**Proposal for Supplement 5 to the 02 series of amendments
to UN Regulation No. 117 amending document
ECE/TRANS/WP.29/GRB/2013/10**

Note: The text reproduced below was prepared by the experts from the Russian Federation as a result from the ad-hoc working group meeting of experts of NAMI (the Russian Federation) and UTAC (France), with the participation of ETRTO organized in accordance with the recommendation of the 58th GRB session (ECE/TRANS/WP.29/GRB/56, para. 15), which endorsed to test the proposed "Deceleration Calculator" tool. This proposal amends document ECE/TRANS/WP.29/GRB/2013/10 distributed at the 58th GRB session. The physic-mathematic principle in this document is not changed relatively to the previous one, but the text of explanations is considerably modified. The modifications to the existing text of the UN Regulation are marked in bold for new or strikethrough for deleted characters.

Figure 1.

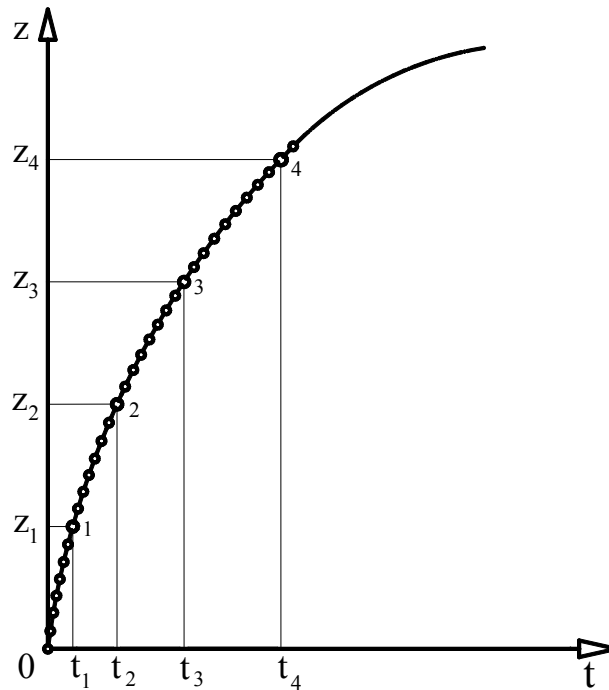
1. Record dependency "distance-time" of rotating body decelerated from peripheral with a speed range such as 82 to 78 km/h or 62 to 58 km/h dependently of PC or CV tyre in a discrete form (figure 1) for rotating body:

- 2.1. Choose the nearest to the maximum value of z dividable by 4 and divide it on 4 equal parts with bounds: $0, z_1(t_1), z_2(t_2), z_3(t_3), z_4(t_4)$.

A is dimensionless constant,
 B is constant in revolutions per second,
 T_{Σ} is constant in seconds,
 m is number of bounds shown in figure 1.
 Insert in these 4 equations coordinates of 4-th bound above.
